PLANT DATA BOOK ENTRY SUBMITTAL SHEET

TITLE: CORE OPERATING LIMITS REPORT FOR THE PERRY NUCLEAR POWER PLANT,
UNIT 1 CYCLE 6 (RELOAD 5)

PDB - F0001 /Rev. 3 EFFECTIVE DATE: 3-22-96

SCOPE OF CHANGE: Incorporate new fuel type information for Cycle 6
including MCPR limits which are fuel type dependent
and delta T dependent.

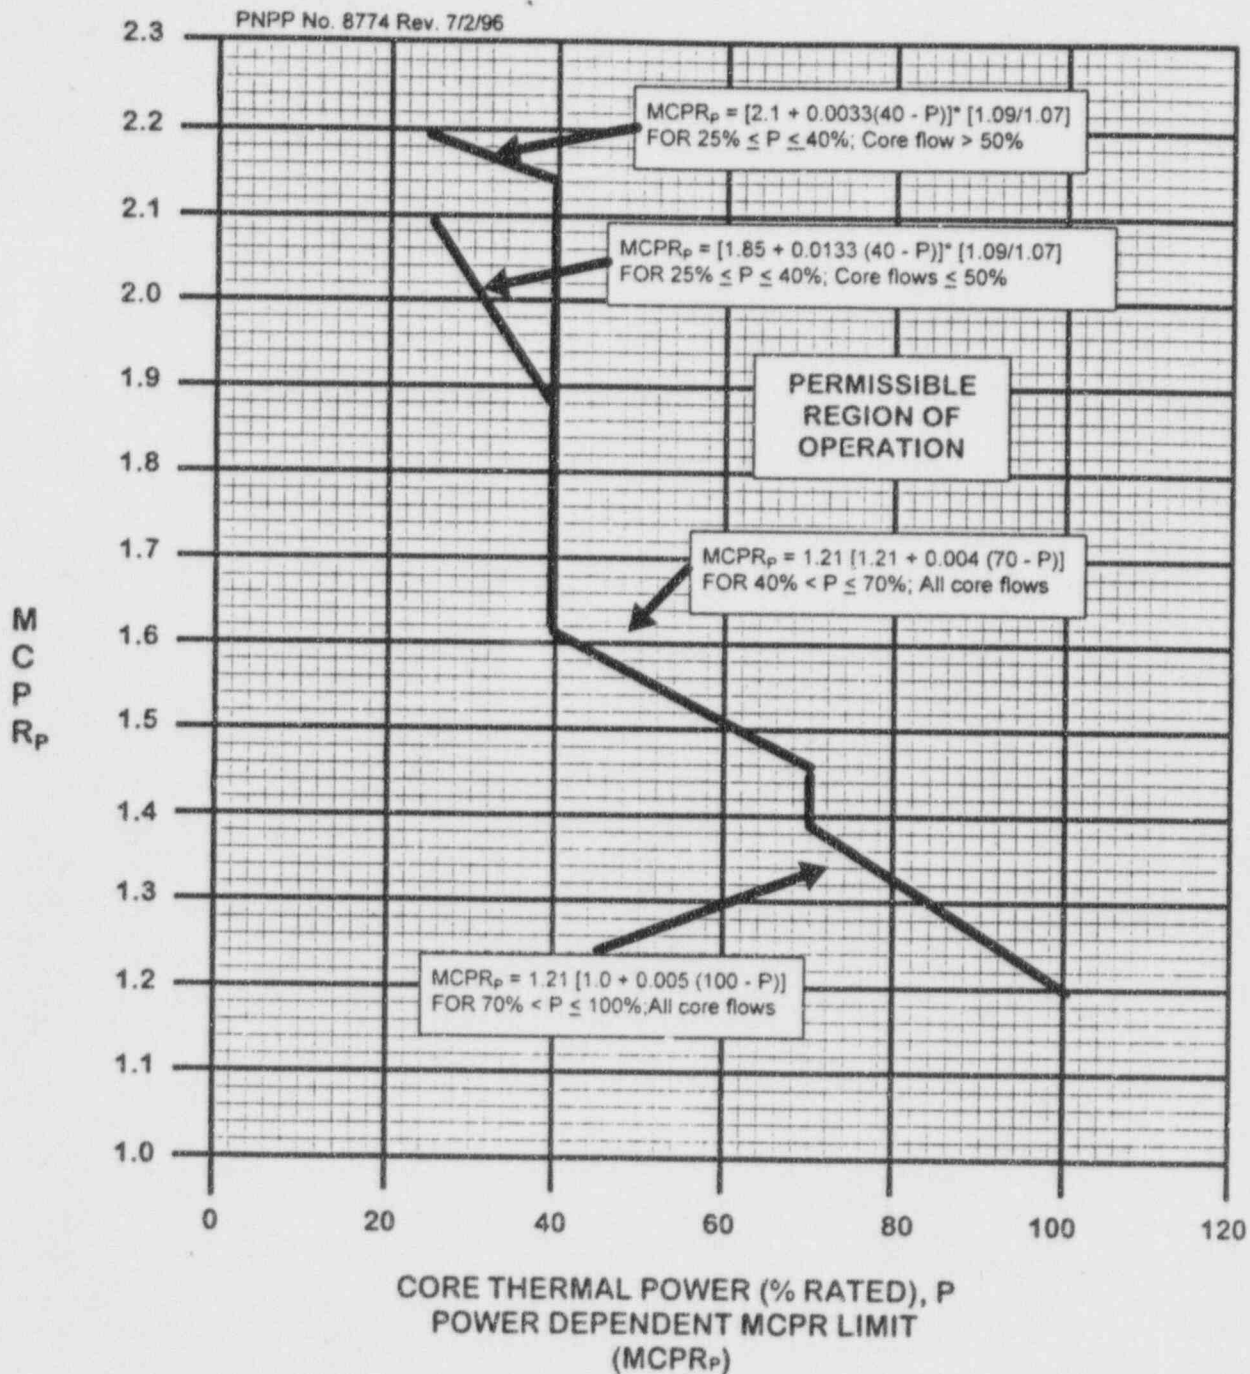
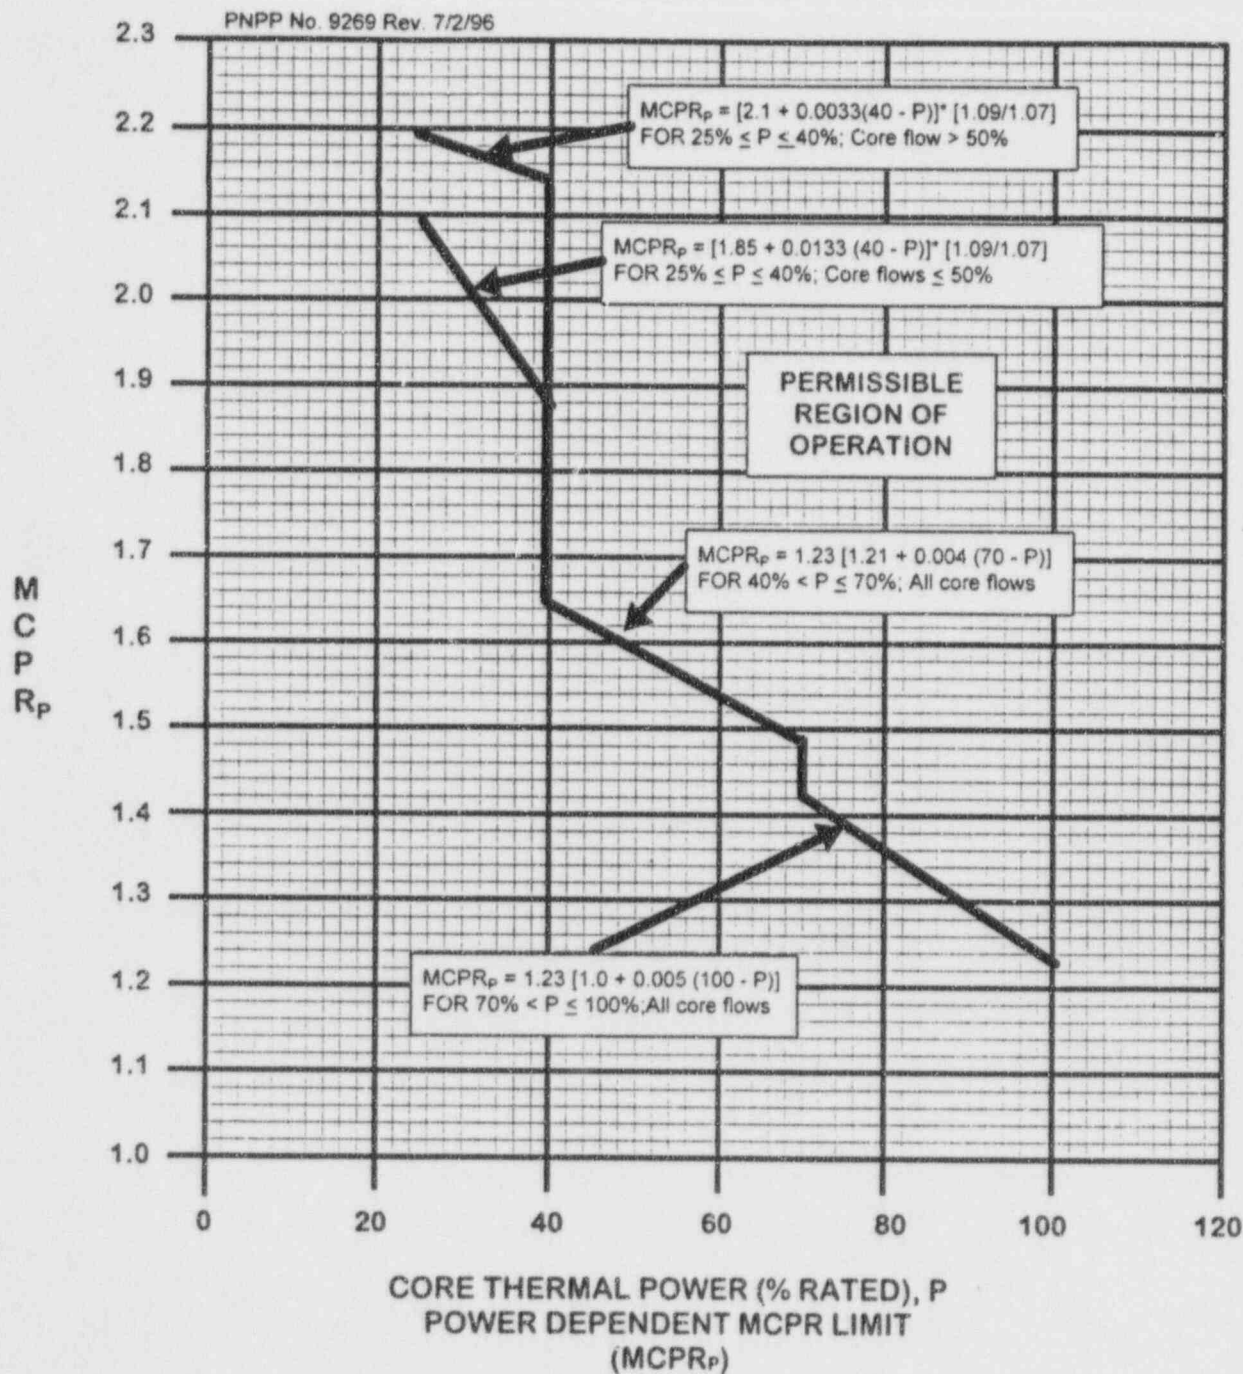
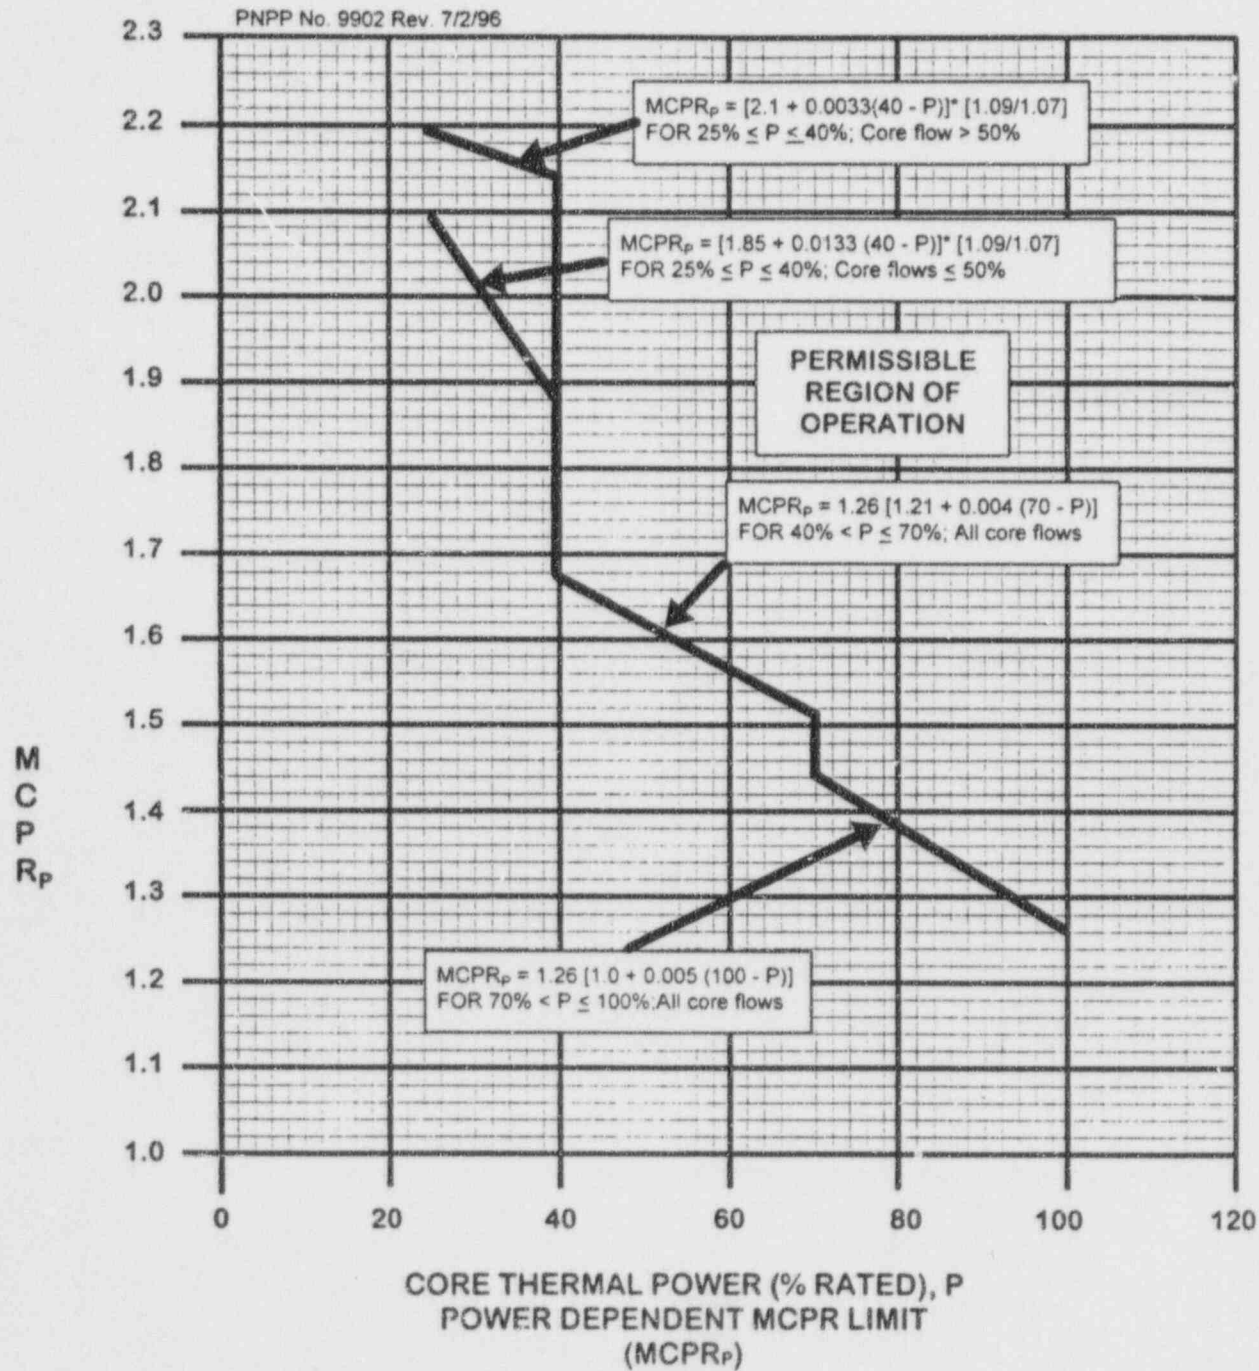
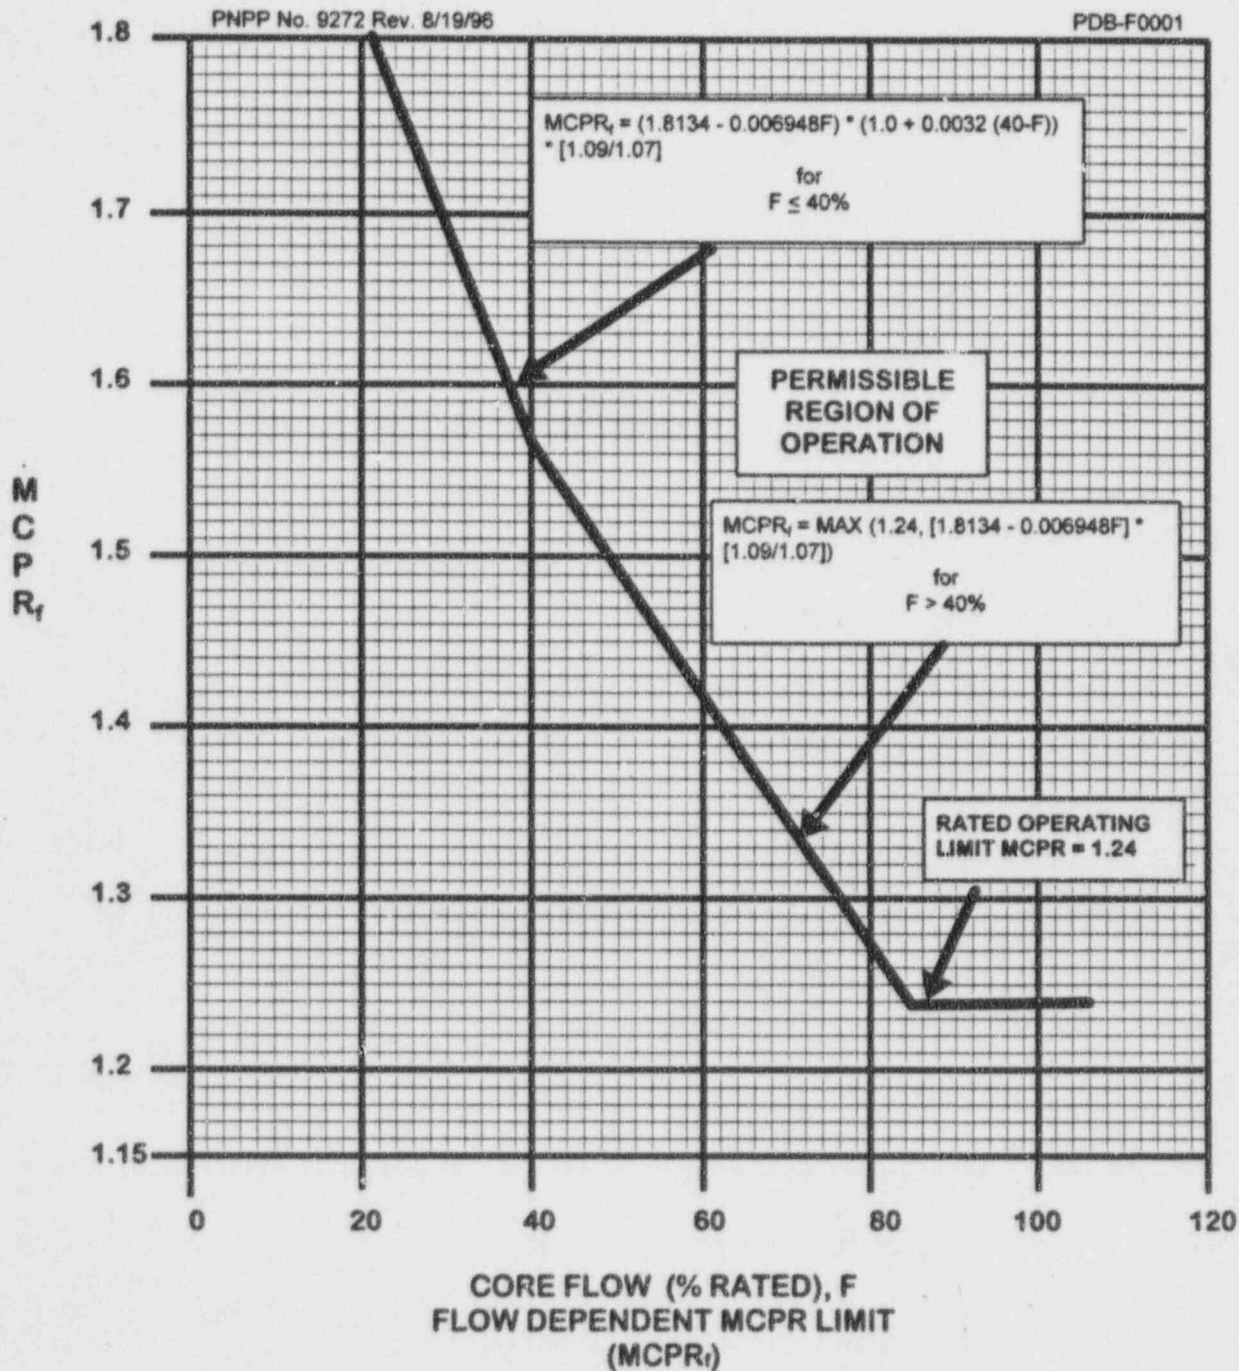
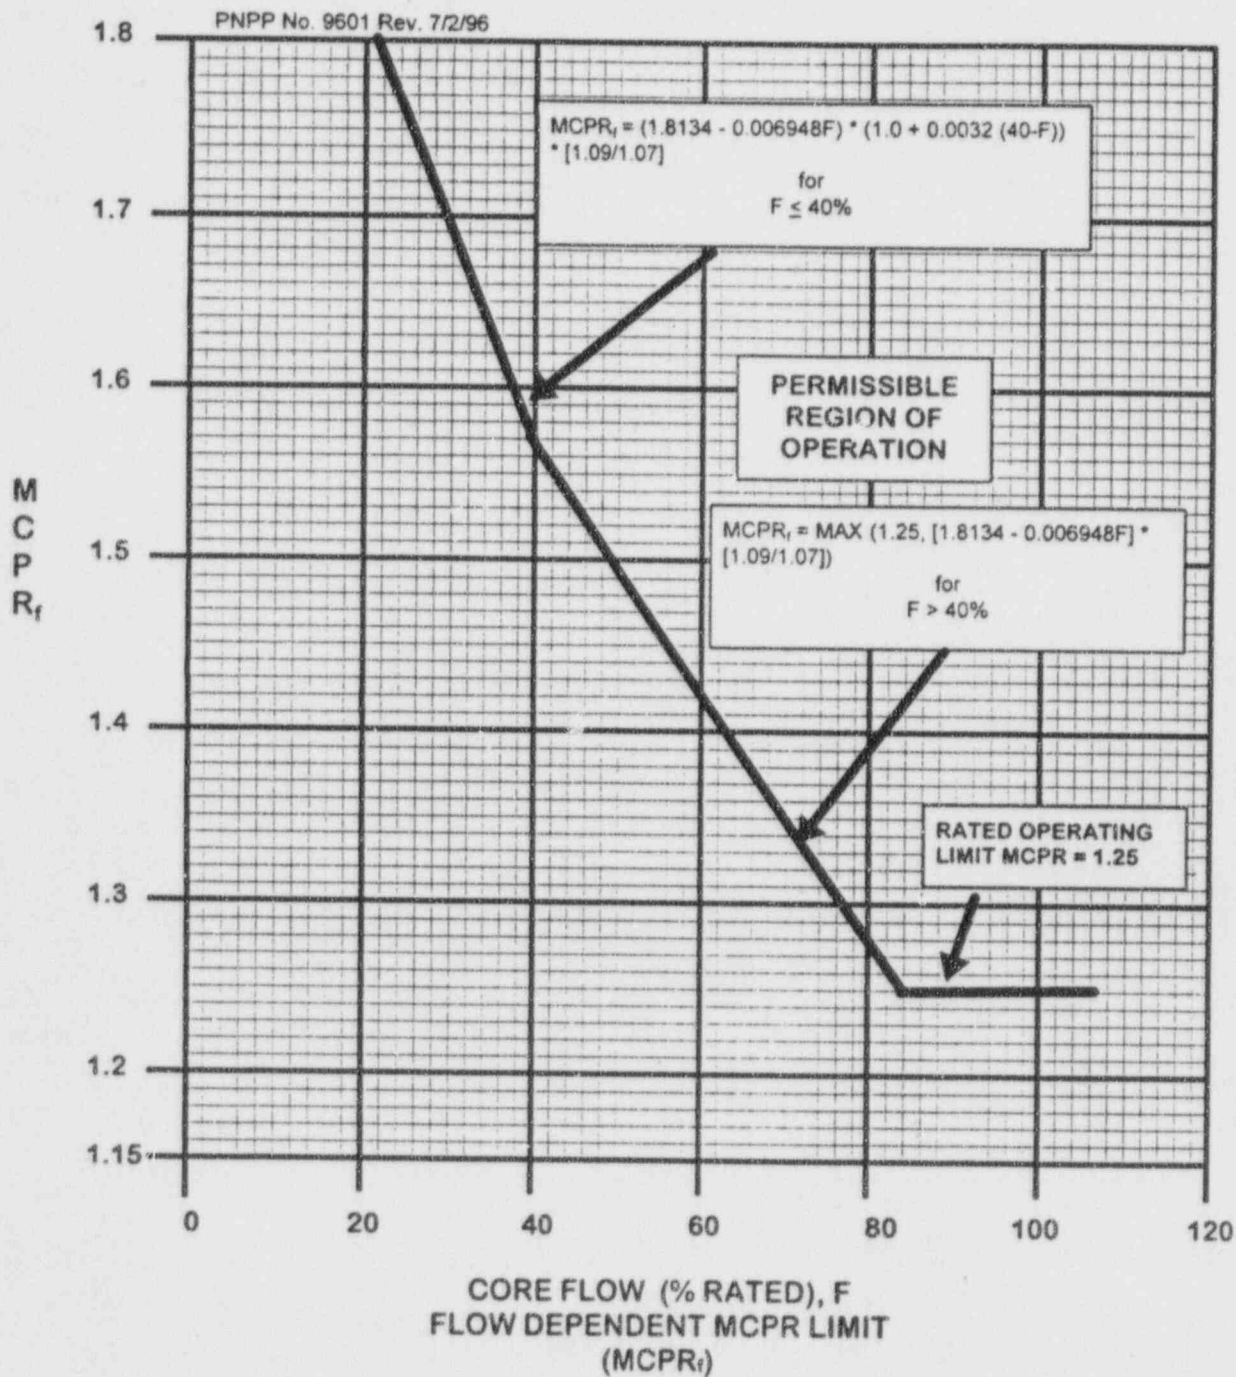
1. The MCPR curves were changed to compensate for the non-conservatism of the generic MCPR Safety Limit.
 2. In the references section, the reference "Supplemental Reload Licensing Report for Cycle 6" was changed to Rev 1 (June 1996).
-
